**FINDINGS OF THE COMMITTEE APPOINTED TO
INVESTIGATE POWER SYSTEM FAILURES ON
NOVEMBER 29, 2021 AND DECEMBER 03, 2021**

ANNEXES OF THE FINAL REPORT

Total Power Failure in the Country on 03rd December 2021

Figure 1

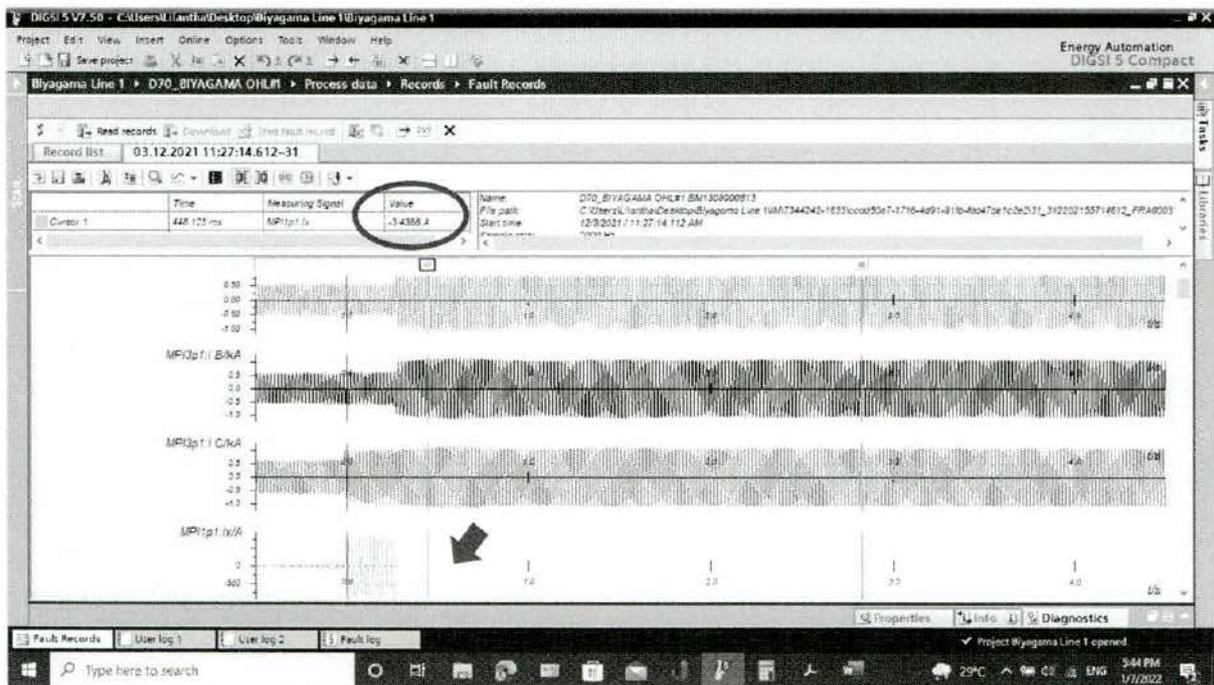
4. The CEB response on page 6 of the Annexure 05 mentions that ***“In the mutual line compensation wiring available in these two circuits, neutral of the parallel circuit is wired to the protection relay. Neutral current shown in Main 01 relay of Line 01 is the neutral current of the Line 02 which has tripped approx. in 288ms. This could have led to the above misleading statement”***. Figure 1 shows the screen shot of fault records of the SIEMENS 7SL87 protection relay of the Line 01 as recorded in the relay. We may be able to accept CEB’s explanation that the neutral current shown in Main 01 relay of Line 01 is the neutral current of Line 02, because it has become almost zero following Line 02 tripping.

Figure 2

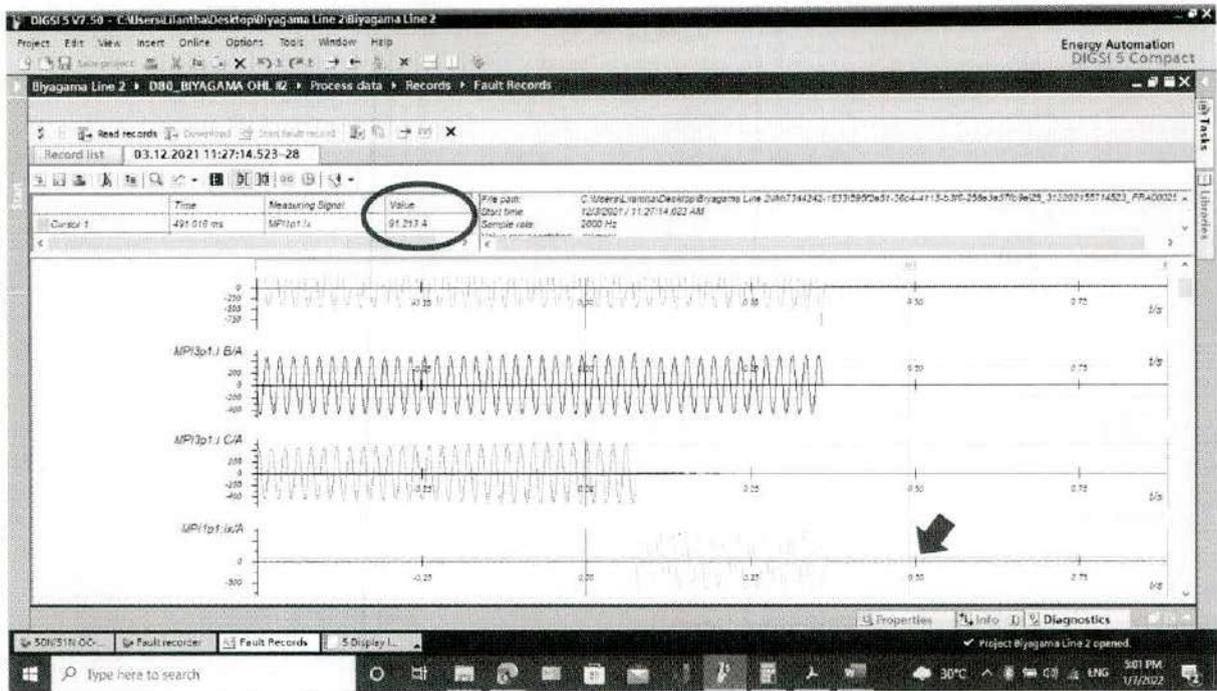
Figure 2 shows the screen shot of fault records of SIEMENS 7SL87 relay as recorded in the protection relay of the Line 02. According to the above-mentioned wiring arrangement explained in the CEB response, the neutral current (bottom waveform) should be the neutral current of Line 01. We note that its peak value following Line 02 tripping is 91.213 A (rms value 64.5 A). According to the explanations given in the CEB response, the setting is 80 A and the pickup current is 10% higher than the setting (88 A) and dropout current is 10% less than setting (72 A). It is noted that the neutral current drops to 64.5 A (which is less than 72A), after 288 ms following the Line 02 tripping. Hence, the Committee finds no reason for the Earth Fault protection to operate as late as 22.33 seconds after, when the current has decreased below the dropout threshold in 288 ms. CEB should explain this issue giving reasons/justifications.

According to the "Pickup & Dropout behaviors of the Inverse Time Curve According to IEC & ANSI" part of the technical manual of Siemens 7SL87 relay, dropout shall be initiated from 0.9 of the threshold value (Figure 07).

Figure 01: Current waveforms seen by Main 1 relay, Main 2 relay and DDR at Biyagama GSS – Kothmale line 2 C phase (In ABC notation)

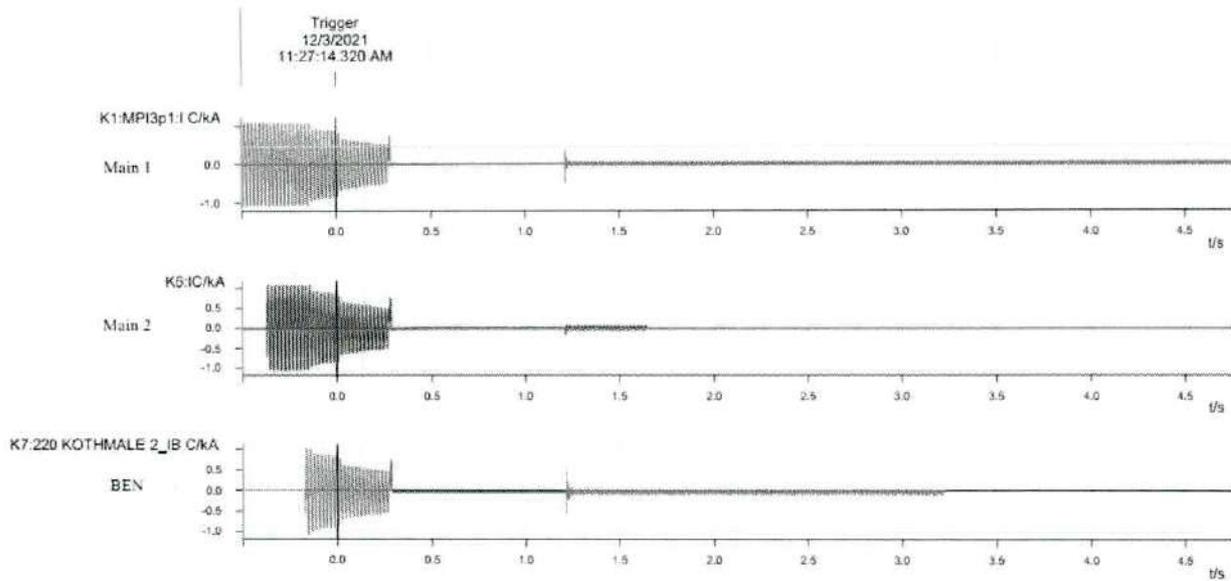
Question 01

Kothmale – Biyagama line 2 has tripped due to the occurrence of C phase (ABC notation) to Earth fault (Differential current of 521 A) in the primary side. The physical arrangement of primary equipment in Kothmale Lines at Biyagama GSS is shown in Annexure I.1.viz. Transmission line, Circuit Breakers, Current Transformers, Line Isolator, Voltage Transformer, Lightning Arrester. This fault current has been recorded in Main 1, Main 2 relays and the BEN6000 Digital disturbance recorder. The recorded waveforms from this equipment are shown below:
